**Petition to Amend Registration Certificate**

- NRC Exempt Distribution License 36-23875-01E
- Registration Certificate NR-1124-D-102-E

## Response to RAI Received on February 28, 2014

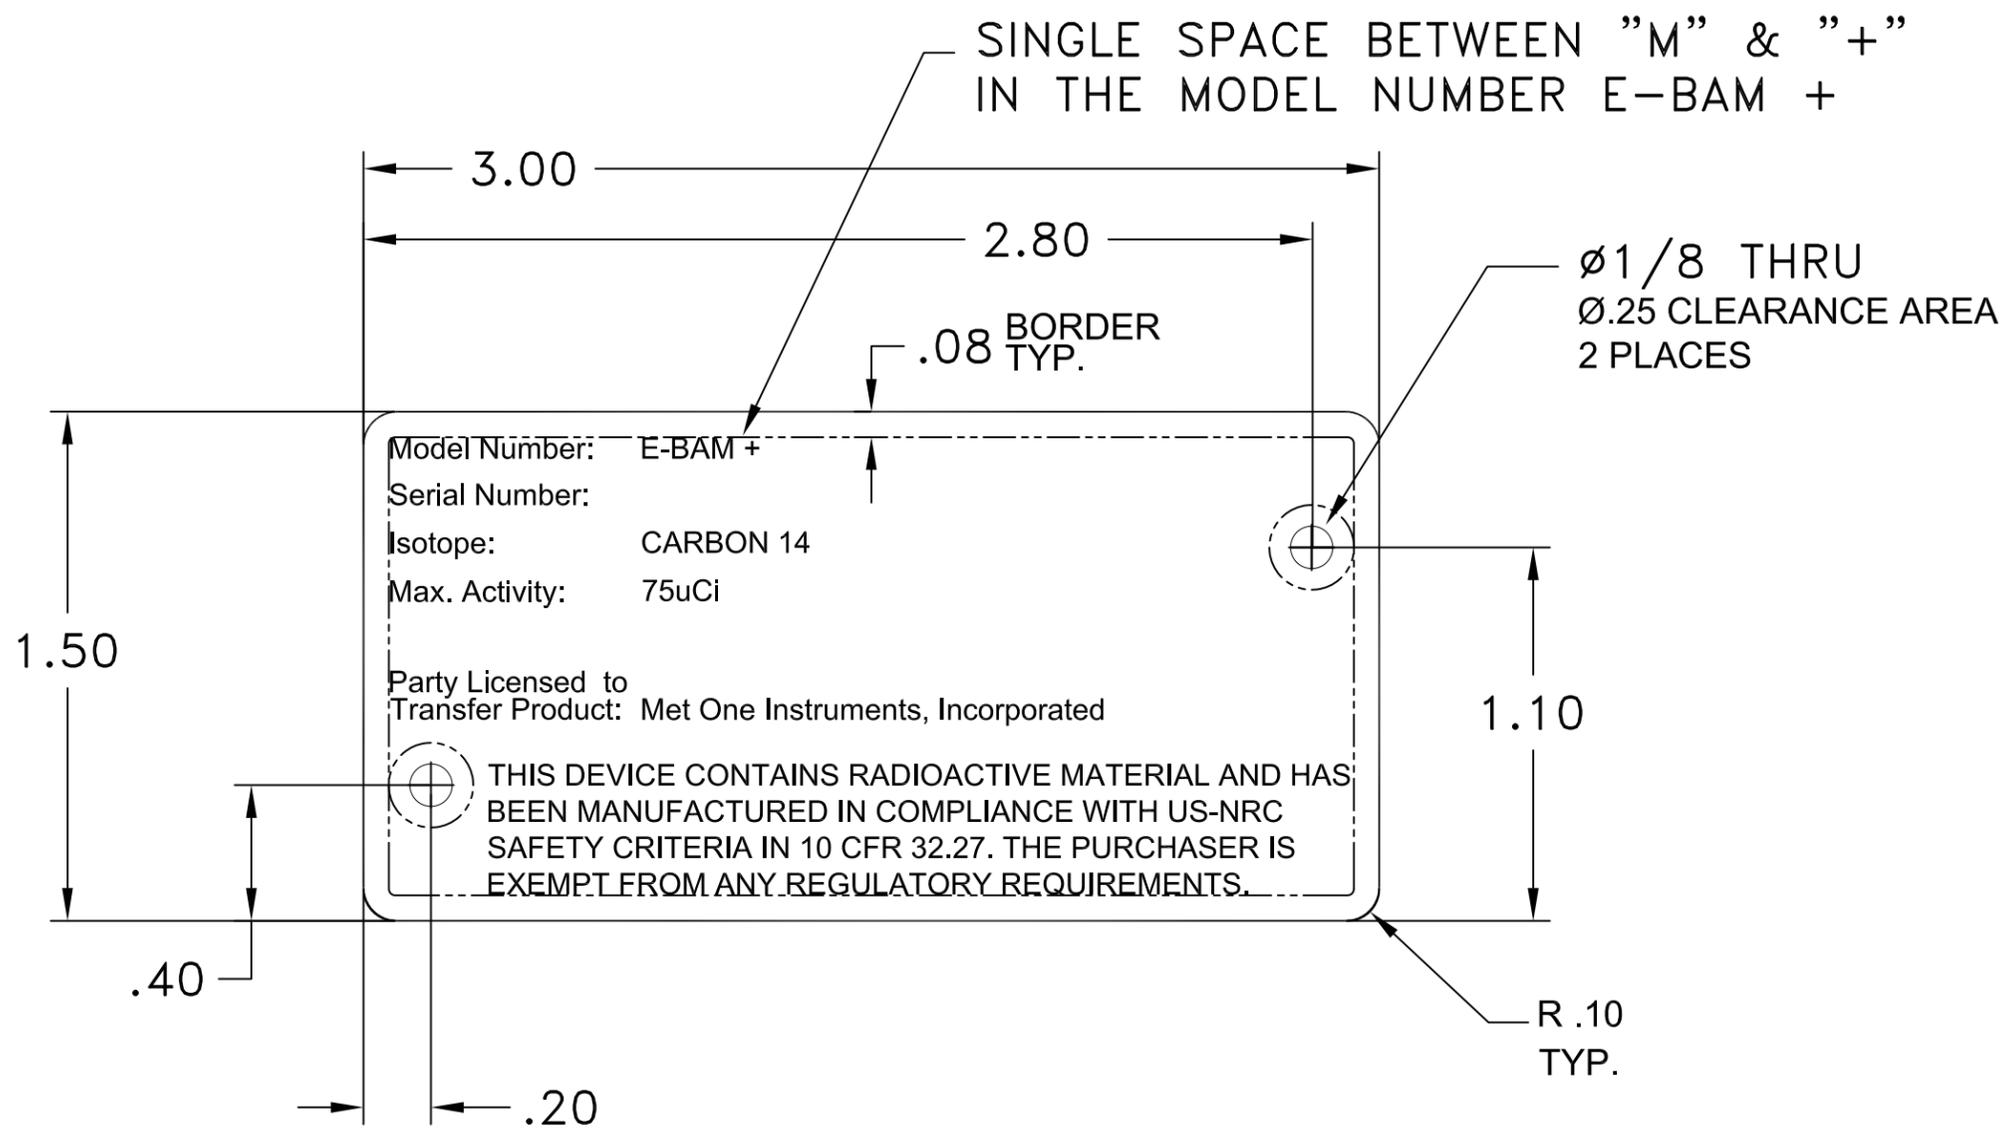
**1. Labeling (Page 1 of 7 and Page 5 of 7): please clarify how the Model “E-BAM EX-10” will be distinguishable from the model “E-BAM?” The photograph on Page 5 of 7 shows the model name E-BAM on the panel; however, this unit is a model E-BAM EX-10. A method of differentiation is needed for all stakeholders.**

We decided to assign a new model to this product. The model is **E-BAM +**. The label is shown below and the drawing is attached (email). The label dimensions are 3” x 1.5”.

Model Number:	<b>E-BAM +</b>	
Serial Number:		
Isotope:	CARBON 14	○
Max. Activity:	75uCi	
Party Licensed to		
Transfer Product:	Met One Instruments, Incorporated	
○	THIS DEVICE CONTAINS RADIOACTIVE MATERIAL AND HAS BEEN MANUFACTURED IN COMPLIANCE WITH US-NRC SAFETY CRITERIA IN 10 CFR 32.27. THE PURCHASER IS EXEMPT FROM ANY REGULATORY REQUIREMENTS.
